**GENOA CHARTER TOWNSHIP
PLANNING COMMISSION PUBLIC HEARING
OCTOBER 10, 2017
TUESDAY
6:30 P.M.
AGENDA**

Attention:	Kelly Van Marter, AICP Planning Director and Assistant Township Manager
Subject:	Livingston Christian Schools – Special Land Use and Site Plan Review #2
Location:	7669 Brighton Road – northwest corner of Brighton and Aljoann Roads
Zoning:	SR Suburban Residential

Re: Livingston Christian Schools Site Plan Review #2

SITE PLAN/TRAFFIC CIRCULATION PLAN

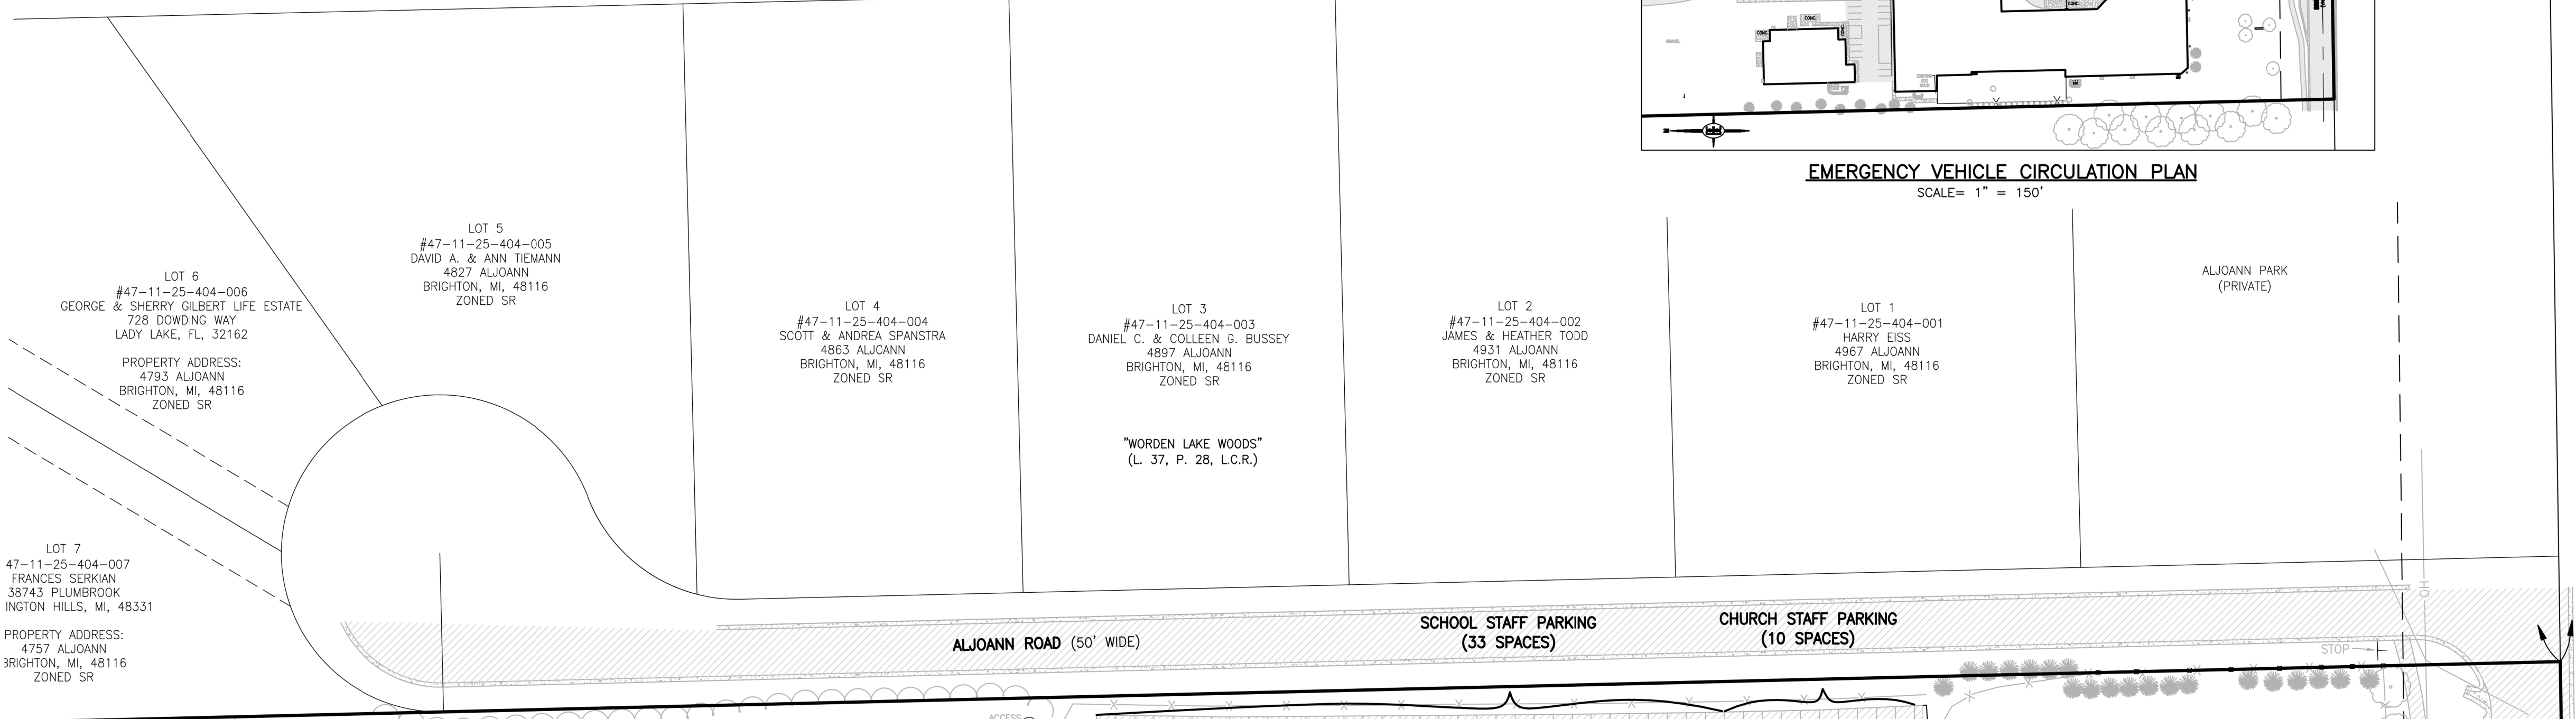
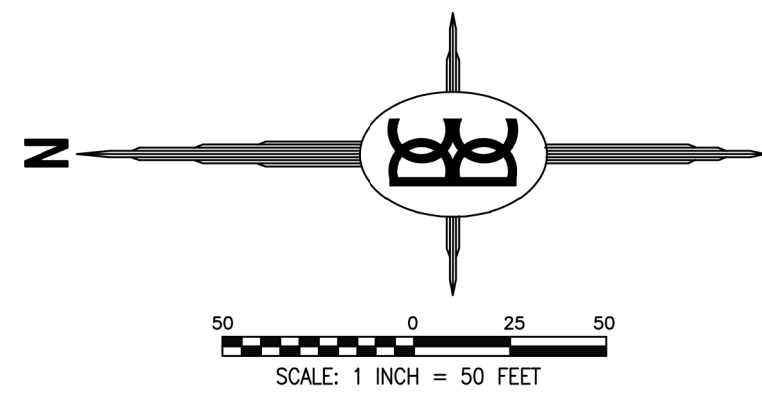
4. The revised site plan notes a slight increase in building coverage (from 6.99% to 8.19%), although no modifications are proposed to the building. The applicant must correct this note.

- 1. Dimensional Requirements.** The district allows a maximum impervious surface ratio of 35%, while the table on Sheet 3 notes that 24.15% will be provided. Additionally, the table also shows an increase in building coverage (from 6.99% to 8.19%), although no modifications are proposed to the building. The applicant must correct this information.
- 2. Building Materials and Design.** No exterior changes are proposed to the existing building(s).
- 3. Parking.** The parking calculations on the site plan demonstrate that as separate uses, the church requires more parking (174) than the school (122). The revised parking lot layout provides 180 spaces.

LANDSCAPE CALCULATIONS

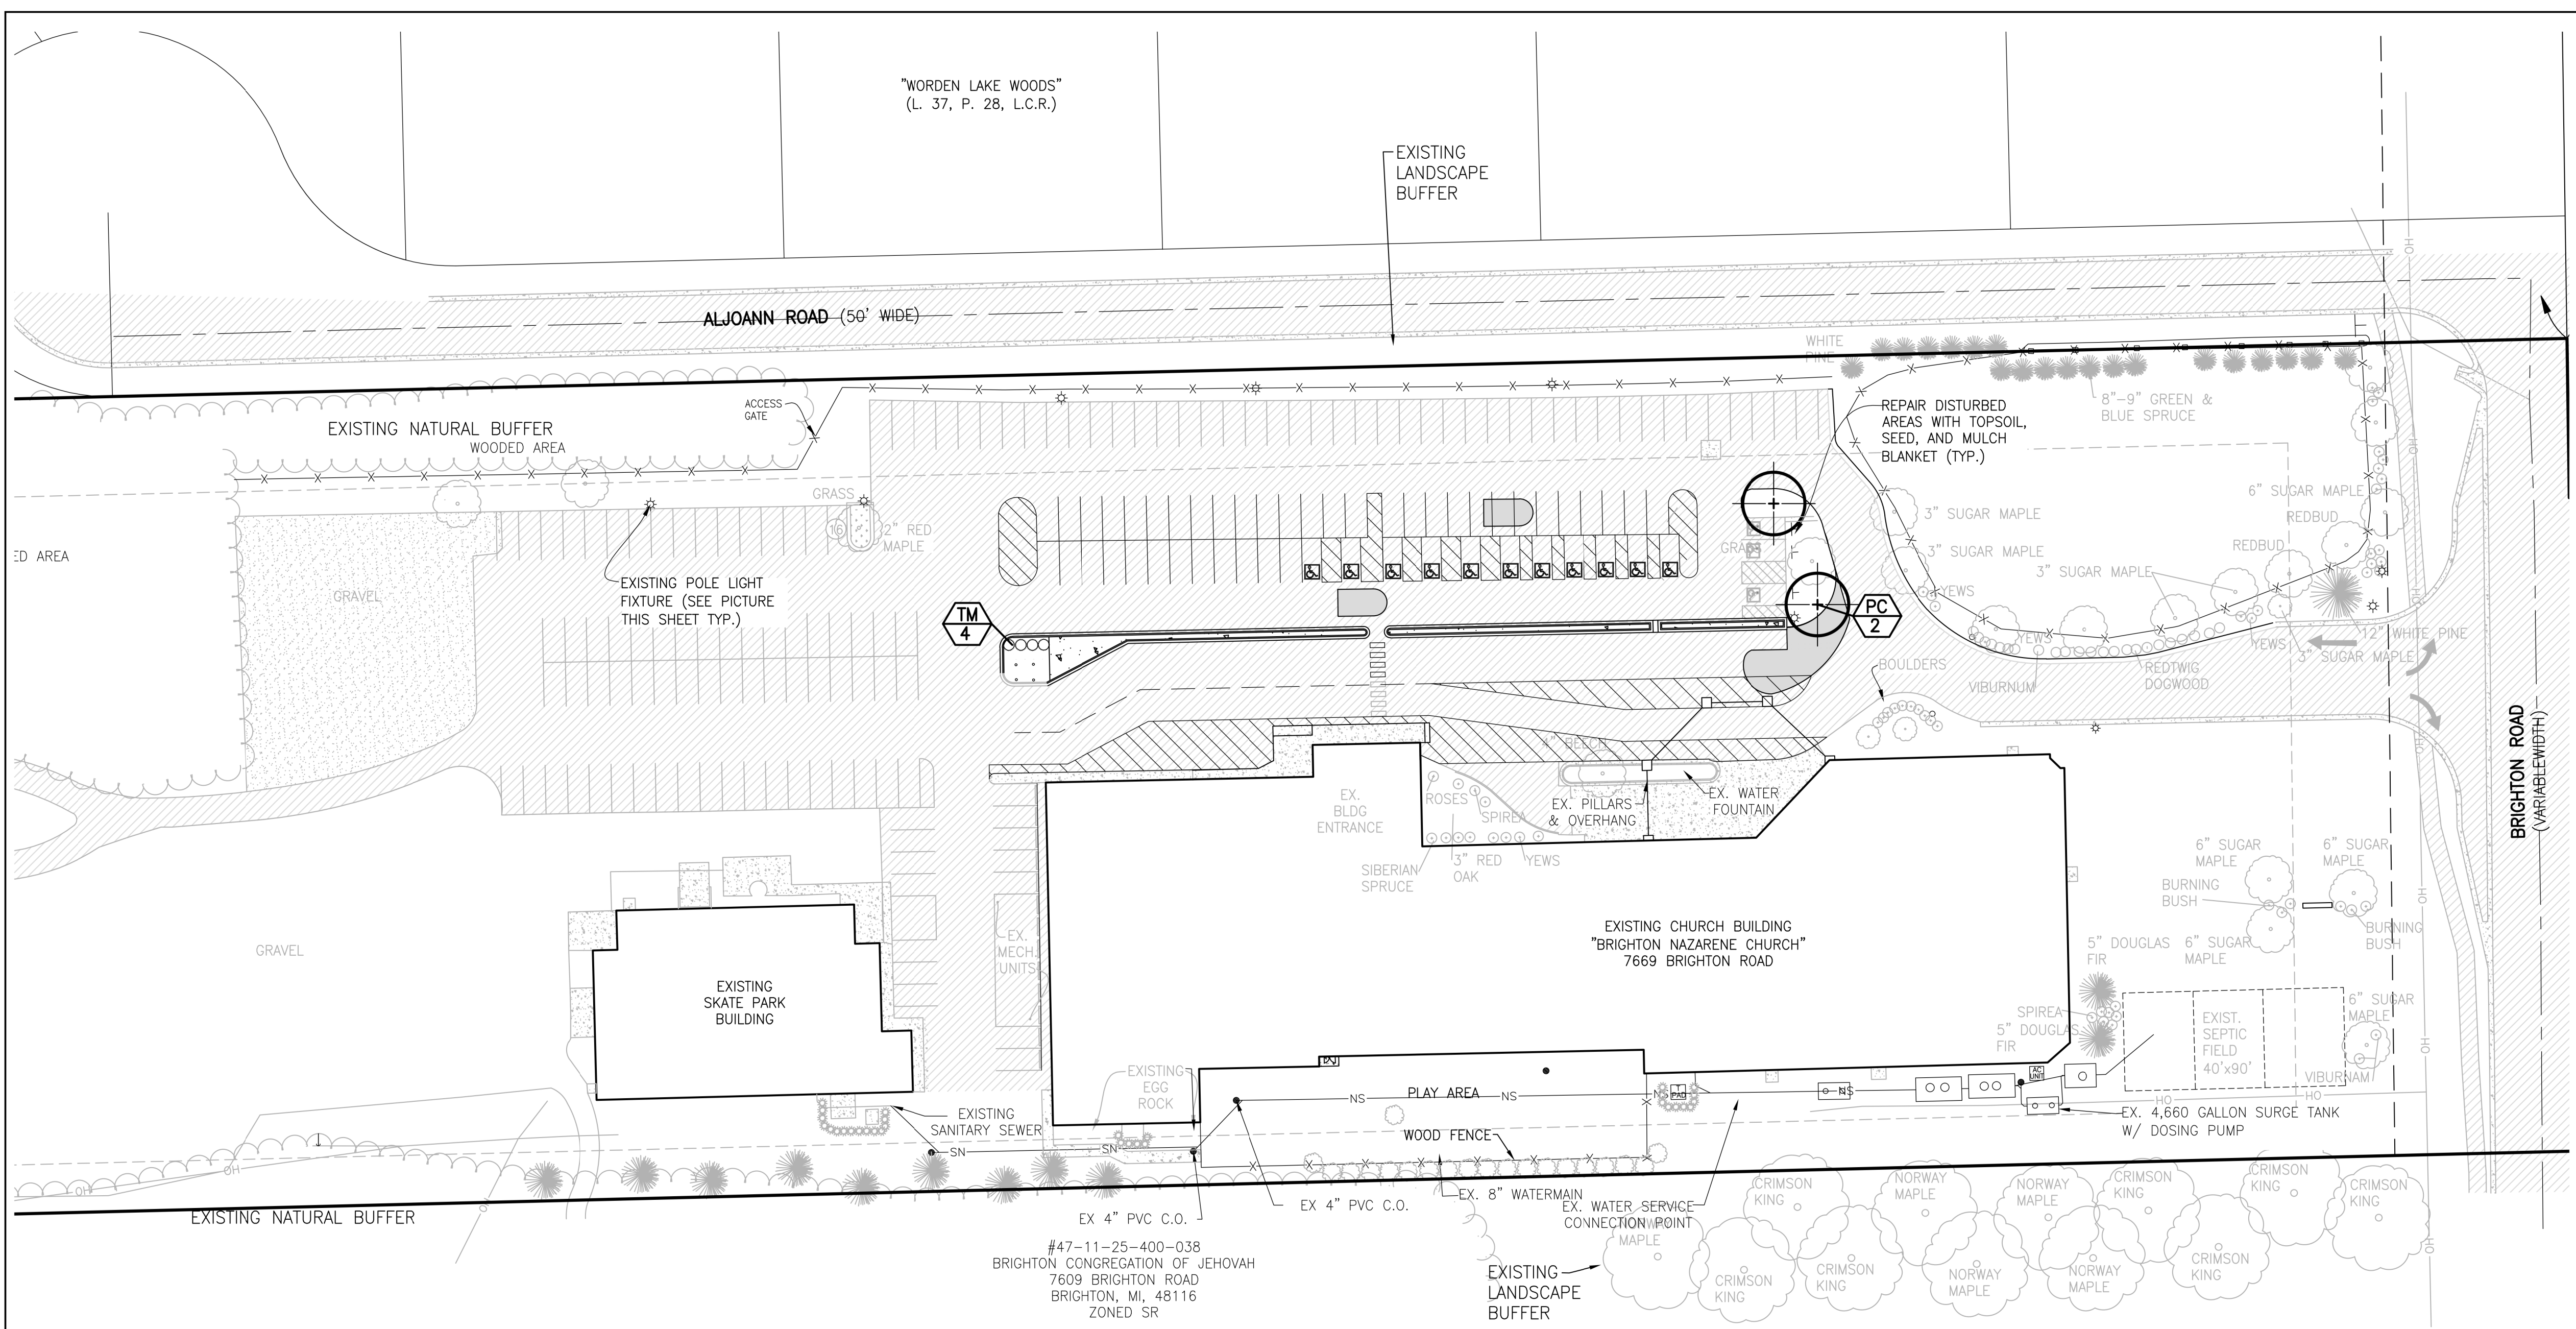
- 5. Landscaping.** The revised landscape plan (Sheet 6) includes new plantings in the form of 2 deciduous trees and 4 shrubs.

The trees are located on the south side of the modified parking lot, while the shrubs are on the north side. Two trees will also be removed as a result of the modified parking lot.
